CHAVIS SUBDIVISION

APPLICATION NUMBER 4 DATE July 8, 2010
APPLICANT Chavis Subdivision
REQUEST Subdivision

DETAIL SITE PLAN

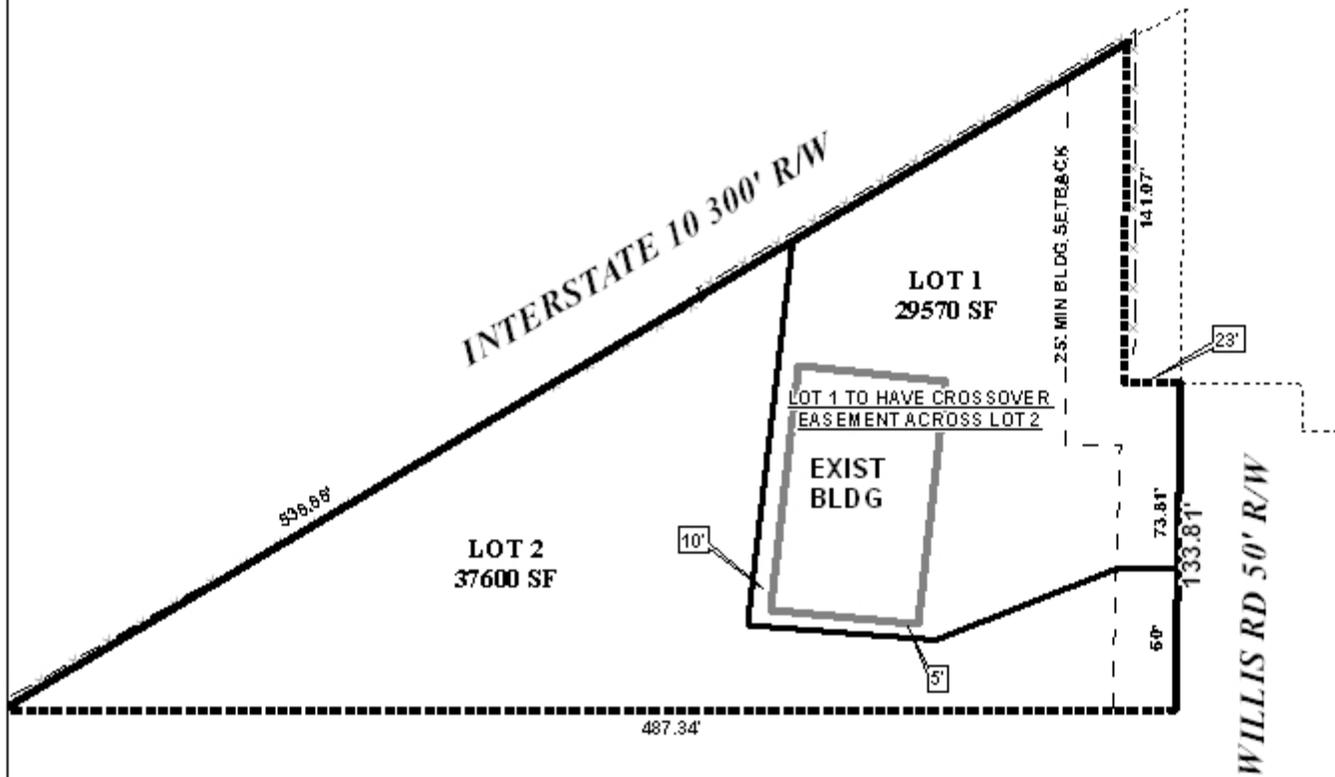
It should be pointed out that there is an existing structure on the site; however, the structure is not depicted on the preliminary plat. Staff is not able to determine if the proposed internal lot line will create a side yard setback issue as it relates to the Zoning Ordinance. The plat should be revised to depict the existing structure and the setback from the proposed internal lot line.

Staff met with the applicant and surveyor concerning the subdivision and a revised plat was later submitted illustrating the existing building on the site. The proposed internal property line is shown with a compliant 10' rear setback off the building; however, the side setback is indicated to be 2.17'. Since the subject property is zoned I-1, Light Industry, the Zoning Ordinance does not require a side yard setback, but if a side yard is provided, it must be at least 5'. Therefore, the proposed side yard setback is not compliant. The building has three service bay entrances, one of which is approximately 10' from the proposed side property line. As the proposed side property line is indicated to turn just past the front of the building and sharply angle across the front of the property, proper access and maneuvering area for the service bay closest to the proposed side property line may be insufficient.

A revised plat was submitted which corrected the side yard setback shortage off the proposed internal property line. However, the plat now states that Lot 1 is to have a crossover easement across Lot 2. As crossover access between two lots would require a Planned Unit Development for shared access and no such application was submitted to be heard in conjunction with this application, no review of access points, parking reconfiguration of proposed Lot 1, or ingress/egress for the southern-most service bays of the existing building can be conducted. Also, no evidence was submitted to show that a flag lot is necessary to allow the site owner reasonable use of the site or to alleviate a situation that would otherwise cause extreme hardship as per Section V.D.1. of the Subdivision Regulations; and, no evidence of a family subdivision was submitted as per Section V.D.1. of the Subdivision Regulations. As proposed, the flag lot would be out of character with other lots in the vicinity as per Section V.D.1. of the Subdivision Regulations.

- 1) no Planned Unit Development application was submitted to address the proposed crossover easement between the two lots to include access points, parking reconfiguration of proposed Lot 1, or ingress/egress for the southern-most service bays of the existing building;*
- 2) no evidence was submitted to show that a flag lot is necessary to allow the site owner reasonable use of the site or to alleviate a situation that would otherwise cause extreme hardship as per Section V.D.1. of the Subdivision Regulations;*
- 3) no evidence of a family subdivision was submitted as per Section V.D.1. of the Subdivision Regulations; and*
- 4) the flag lot would be out of character with other lots in the vicinity as per Section V.D.1. of the Subdivision Regulations.*
